Leighton Consulting, Inc.

Subject: Geotechnical Response to City of San Diego
Cycle 7 BDR-Geology; L64A-003A
Federal Blvd M.O.
City of San Diego, PTS No. 644432

Cycle 3 BDR-Geology Comments, PTS No. 607976

FIGURE 2
Geotechnical Map

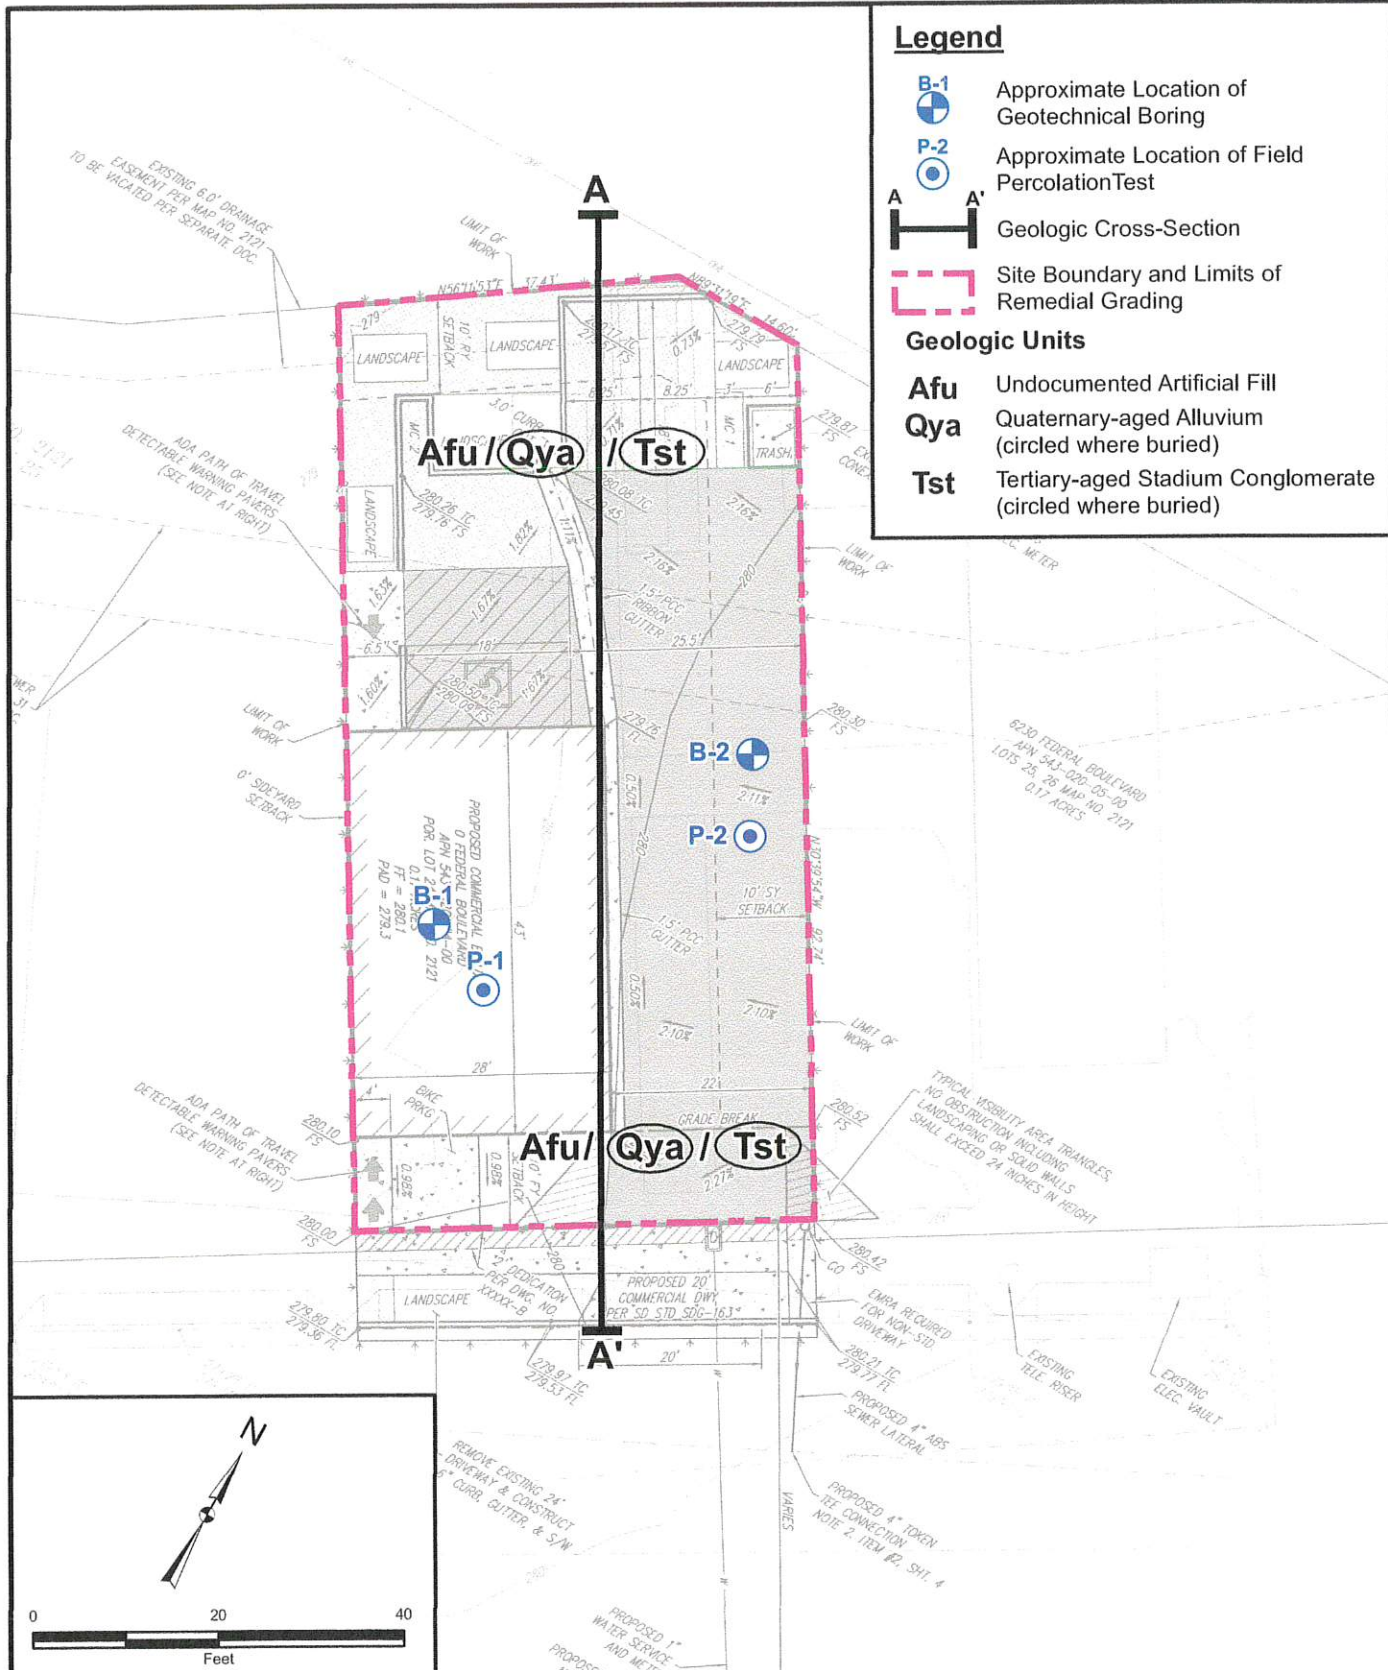
- 4 *Provide an updated/geotechnical map that shows the distribution of fill and geologic units, location of exploratory excavations, and current proposed construction on a topographic base map.*

See attached Figure 2 (Geotechnical Map).

FIGURE 2
Geotechnical Map

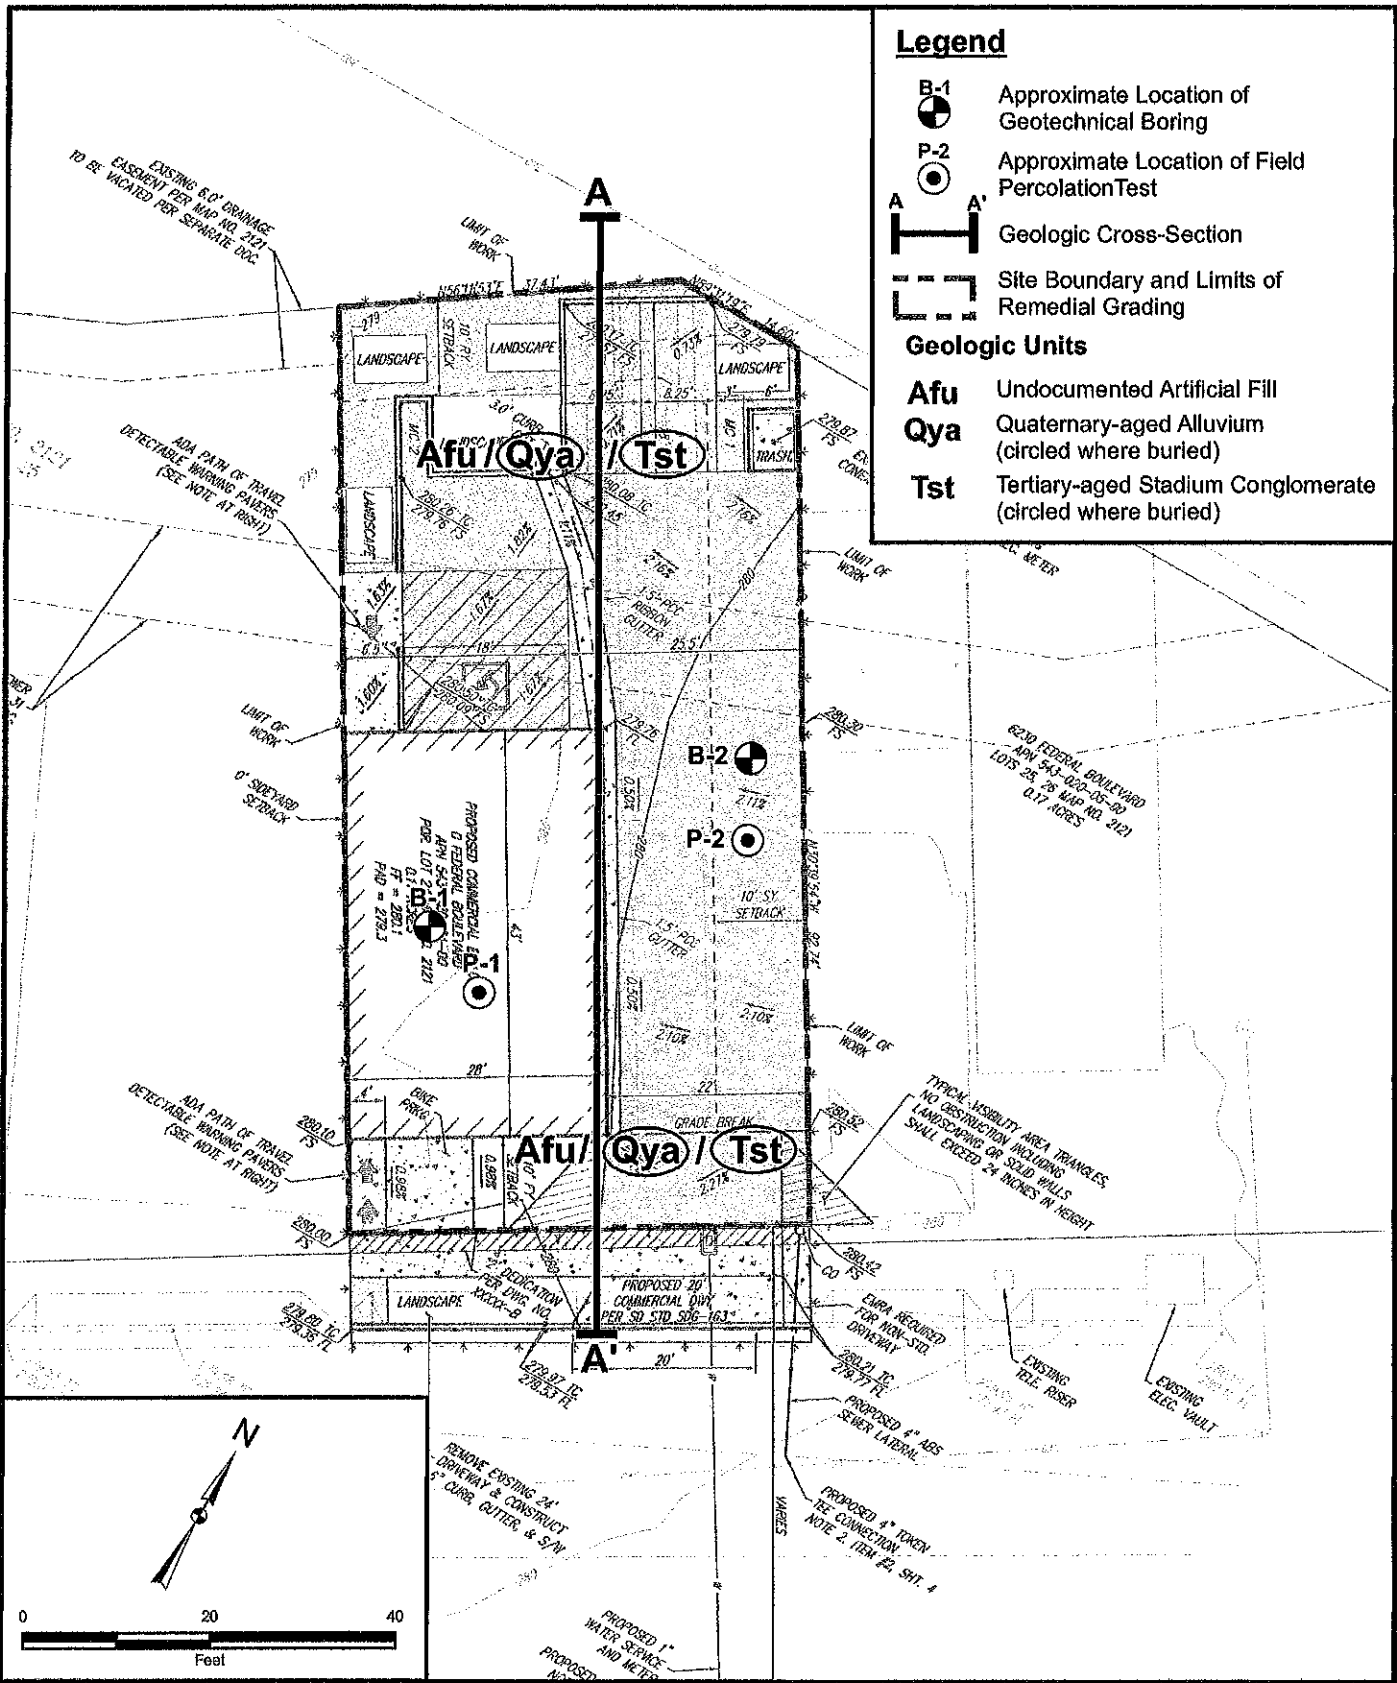
- 4 *Provide an updated/geotechnical map that shows the distribution of fill and geologic units, location of exploratory excavations, and current proposed construction on a topographic base map.*

See attached Figure 2 (Geotechnical Map).
